**STAFF REPORT:** 02/11/2026 REGULAR MEETING

**APPLICATION NUMBER:** HDC2026-00018

**ADDRESS:** 4324 (4314-4316) W. VERNOR

**SCOPE:** REMOVE BRICK VENEER AT FAÇADE, INSTALL NEW BRICK CLADDING AND STOREFRONT SYSTEM

Staff photos, 10/24/2025. No elements within the yellow box are historic.

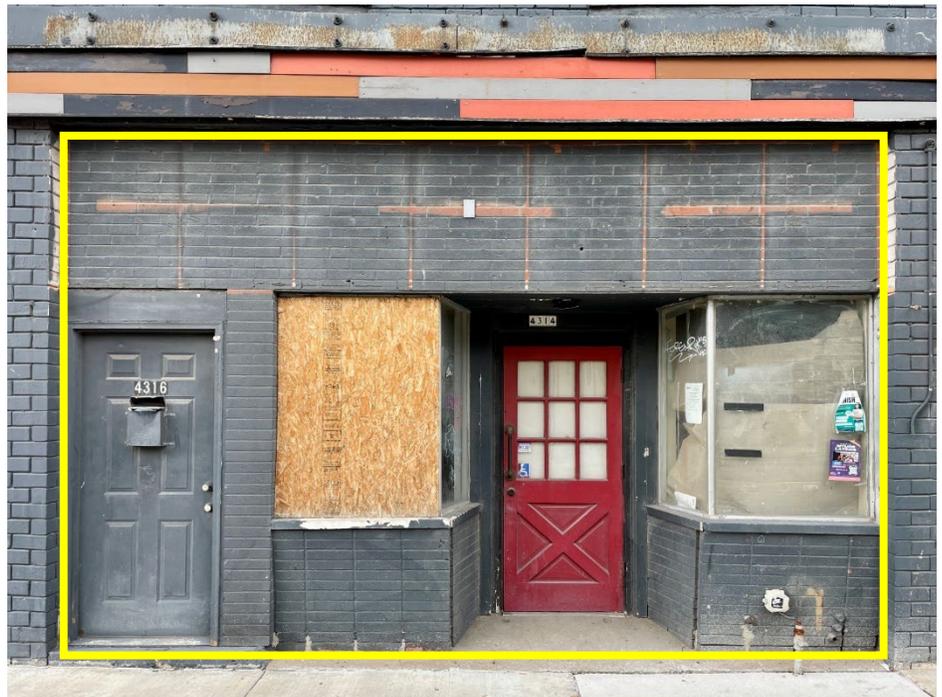
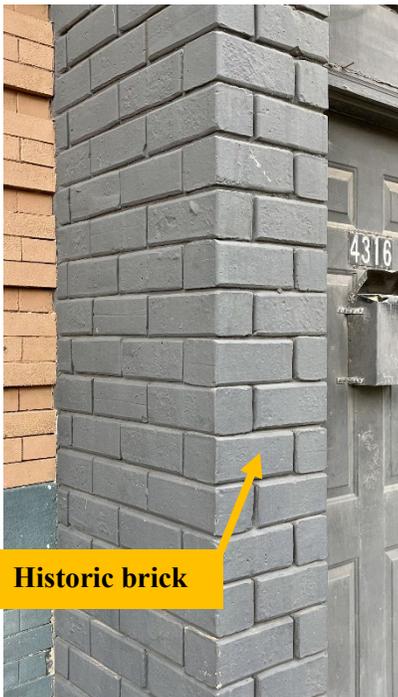
- The existing storefront, characterized by its mostly brick infill and minimal detailing, appears to reflect a more modern, mid-century design. This is evident in the use of thinner, elongated bricks, which contrast with the more ornamental features, such as decorative wood panels, typically found in earlier historic storefronts.

Proposal Analysis

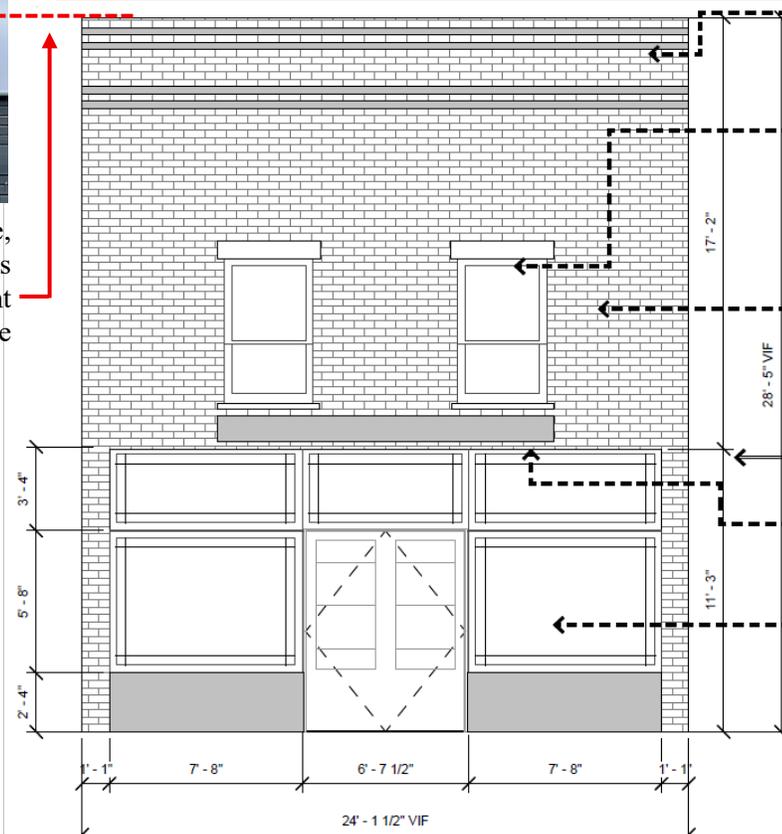
With the new façade, the applicant proposes to increase the height to align with the building to the West.

- Staff would like to note that the proposed new brick size does not match the existing historic brick in size. If replacement brick veneer was warranted (that is, if the historic brick veneer was demonstrated to be beyond repair), the new brick veneer would be required to “match the old in design, color, texture, and other visual qualities, and where possible, materials” (Standard #6, quoted in full below).

- It is staff’s opinion that the applicant’s proposal to remove the existing historic brick veneer at the façade is inappropriate, as the existing brick veneer is a distinctive, character-defining feature and has not been demonstrated to be beyond repair. Furthermore, the proposed new brick cladding, with its smaller individual brick size and increased cornice height and detailing, conveys a misleading representation of historic brick architectural details and creates a false sense of historical development. These elements are incompatible with the building’s authentic and simplistic historic character.

- Even if found by the Commission to be beyond reasonable repair, Standard #6 dictates that distinctive features must be replaced to match historic conditions. Altering the parapet height and brick sizes does not satisfy this requirement. The correct preservation treatment, should retention of the second story façade prove unreasonable under the Standards, is a faithful reproduction of the existing masonry and parapet in size and design.

### **Recommendation 1 of 2 – Denial – Remove brick veneer at façade, install new brick cladding**

- The historic brick veneer at the façade is a distinctive, character-defining feature and not proven to be beyond repair.
- Introducing features that are not based on documented historical evidence, including architectural elements copied from other buildings and styles, creates a false sense of history.
